# Access Compliance Report

## Public Rights-of-Way

### (Curb Ramps)

Intersection ID: 11894	Main Street: N_BREVARD_ST	Cross Street: E_12TH_ST	Location: N
ADA ID: 6D3B732824ED	Ramp Type: Perp	Initial Pass/Fail: Fail	Overall Compliance: No
Severity Score: 8.75			
Codes/Mitigation Info/Possible Solution		Field Measurements/Component Compliance

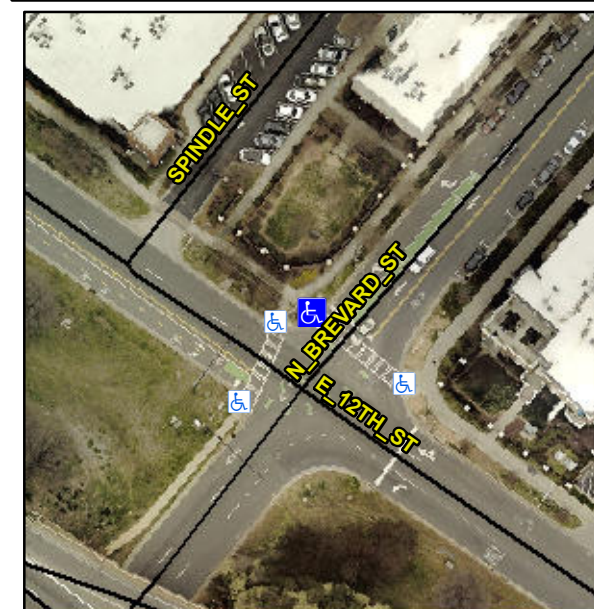
**Not Found, R304.5.1**

Compliance	Description	Data	Compliance	Description	Data
N/A	Ramp Length (in)	72.0	Yes	Ramp Slope (%)	7.7
No	Ramp Width (in)	47.5	Yes	Ramp XSlope (%)	0.6
N/A	Flare Type LT	N/A	N/A	Flare Type RT	N/A
N/A	Flare Slope LT (%)	N/A	N/A	Flare Slope RT (%)	N/A
N/A	Flare Traversable LT?	N/A	N/A	Flare Traversable RT?	N/A
N/A	Landing Length (in)	N/A	N/A	DWS Provided?	N/A
N/A	Landing Width (in)	N/A	N/A	DWS Contrast?	N/A
N/A	Landing Slope (%)	N/A	N/A	DWS Length (in)	N/A
N/A	Landing X Slope (%)	N/A	N/A	DWS Full Width?	N/A
N/A	Landing Curb? (Y/N)	N/A	N/A	DWS Offset (in)	N/A
N/A	Shared Landing?	N/A			
N/A	Gutter Ponding?	N/A	N/A	Gutter Slope (%)	N/A
N/A	Gutter Lip Ht (in)	N/A	N/A	Gutter X Slope (%)	N/A
N/A	Painted X Walk1?	Yes	N/A	Painted X Walk2?	N/A
	X Walk 1 Direction	To SE		X Walk 2 Direction	N/A
N/A	X Walk 1 Width (in)	87.0	N/A	X Walk 2 Width (in)	N/A
	X Walk 1 Slope (%)	2.6		X Walk 2 Slope (%)	N/A
	X Walk 1 X Slope (%)	1.8		X Walk 2 X Slope (%)	N/A

**Remove & Replace Entire Ramp.**
